Product Change Notification

PCN-IFC-5812-2020

Business Unit	Product Line Code	Type of Change	Action	Date of Issue
IFC - Industrial Field Connectivity	BF7	Product Change Notification	Notify Distributors and Field	9/25/2020

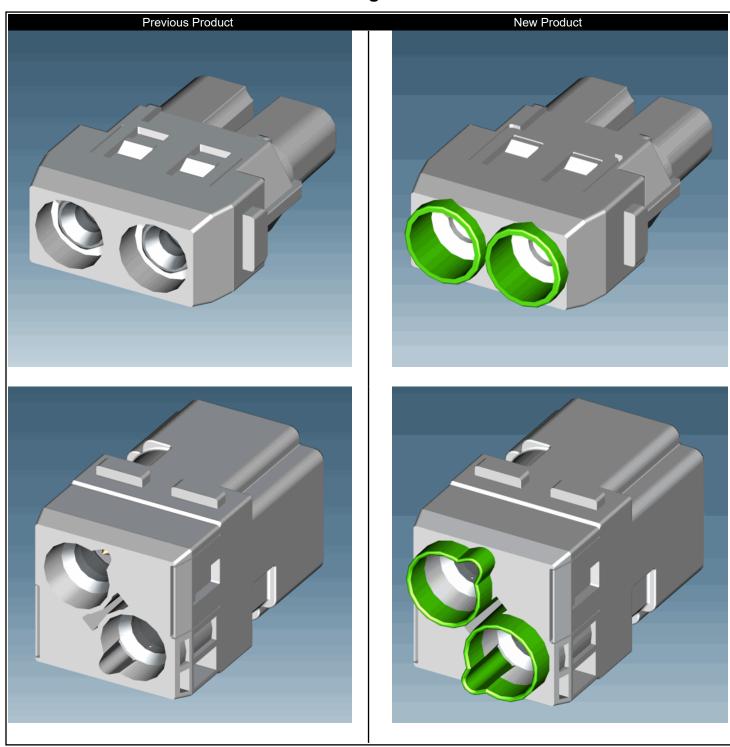
To improve the handing and termination of wires into the axial screw power insert modules for 100A and 70A requirements, we recently added a short collar to the rear of the inserts.
